International Aero Engines

SERVICE BULLETIN

<u>ENGINE - HP COMPRESSOR - STAGE 9 ROTOR BLADES WITH MODIFIED PLATFORM PROFILE - CATEGORY CODE 7 - MOD.ENG-72-0174</u>

Location of stage 9 compressor blade Fig.1

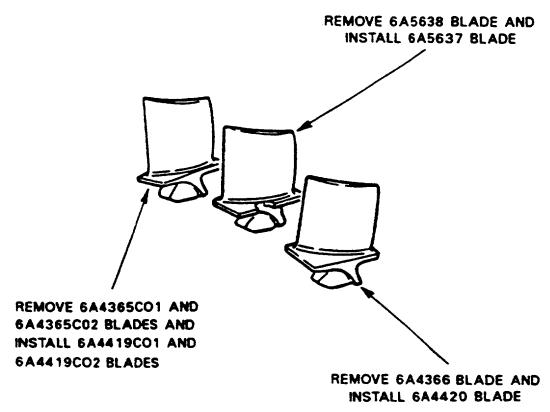
This Service Bulletin introduces stage 9 HP compressor rotor blades with the platform thickness tapered off in two steps from the dovetail to the trailing edge. This change eliminates the need to cut back the rear trailing edge platform corner. Accordingly, the modified blades feature a full platform. The exceptions to this are the LH and RH locking blades. The LH locking blade retains the rear cut-back introduced by SBE-V2500-ENG-72-0109. The RH locking blade retains the front cut-back introduced by SBE-V2500-ENG-72-0172.

The partial shot-peening currently applied to the underside of the rear platform of all blades is extended to the trailing edge.

An angled cut-out on the LH locking blade sealing wing is introduced to eliminate a cusp situated between the dovetail rear profile and rear corner of the locking slot.
